Dear Dennis Kuhnel and Canyon Lakes Ranger District Staff,

I am Kenny Bearden, the Executive Director of the Overland Mountain Bike Association. Our organization helps to maintain several trails within the project area, and we have been highly involved in rehabilitating trails on the Canyon Lakes Ranger District following the Hewlett Gulch, High Park, and Cameron Peak Fires. We appreciate the general goals of the plan to restore forested ecosystems and reduce wildfire risk to communities within and adjacent to the project area. We are writing to express concern over one element of the proposed plan pertaining to the designation of Killpecker Trail (trail number 956) as a Potential Operational Delineation (POD) boundary (Figure 1) and the possible activities that could be used to improve it to function as a wildfire containment feature.

Figure 1: POD boundary in question from Appendix C, Map 9.

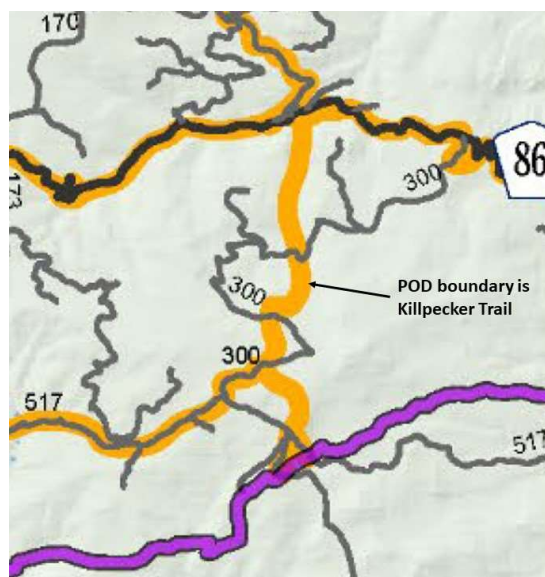
We see several conflicts with applying the activities described for POD boundaries to Killpecker Trail:

- Intensively managing fuels within a 300 to 1,000-ft wide zone around the trail (width from Preliminary Purpose & Need and Proposed Action, page 32) would dramatically alter the visitor experience of the trail and may be impractical to achieve along much of the lower half of the trail due to its proximity to the stream and several sections that are confined to a canyon with steep side slopes.
- We are especially concerned that lodgepole clearcuts would be implemented along the accessible sections of the trail as described in the management activity cards (Appendix A, activity cards 4 and 5). Many people choose to recreate on these trails in the summer because of the cooler temperatures and shade of the forest. Clearcuts have recently been implemented along sections of Killpecker Trail and the nearby North Lone Pine Trail (trail number 953) to the detriment of the user experience.

- We are also concerned that designating Killpecker Trail as a POD boundary could lead to trail widening and damage through several mechanisms:
 - Directly through the implementation of mechanical treatments, especially that involve temporary road or skid trail construction along or over the trail.

- Indirectly from the thinning or clearcut activities improving four-wheel vehicle access to the trail. Illegal four-wheel vehicle use has been an issue on the trail. Investments were recently made to gate all the trail access points along Killpecker Road to keep four-wheel vehicles off the trail but opening up the forest along the trail could render this management tactic ineffective.

- Indirectly from encouraging high-impact suppression tactics such as dozer line construction along the trail during future wildfires. Dozer line was constructed over the top section of the North Lone Pine Trail during the Cameron Peak Fire without being repaired. We worry about similar outcomes if Killpecker Trail is viewed as a preferred wildfire containment feature. The outcomes of such actions on Killpecker Trail could be worse due to the proximity to the stream.

- Please consider alternative wildfire control features in the nearby area that could meet the intent of this POD boundary while avoiding recreation impacts. Many sections of the Killpecker Road already meet the POD boundary design criteria described in the preliminary plan. The Killpecker Spur Roads (300.A and 300.B) also appear to be reasonable options that could support better vehicle access for fire suppression than a singletrack trail.

- If alternative locations for the POD boundary are not acceptable, please consider applying the primary management actions for POD boundaries in roadless areas to Killpecker Trail and other trails (Preliminary Purpose & Need and Proposed Action, page 52-53). Hand thinning of small diameter trees, pruning lower limbs, and piling and burning the cut materials would preserve more of the character of the trail compared to large clearcuts. These activities may even benefit the recreational experience by removing some of the abundant snags which frequently fall and block the trail. Given the intent for this to be a flexible plan, we encourage you to describe a separate set of activities for POD boundaries along recreational trails, so these standards would apply to all other locations.

- Please consider adding emphasis to the lodgepole clearcut management activity cards (Appendix A, activity cards 4 and 5) to indicate that “interpatch reserves” should be prioritized along trails to mitigate impacts on the recreational experience.
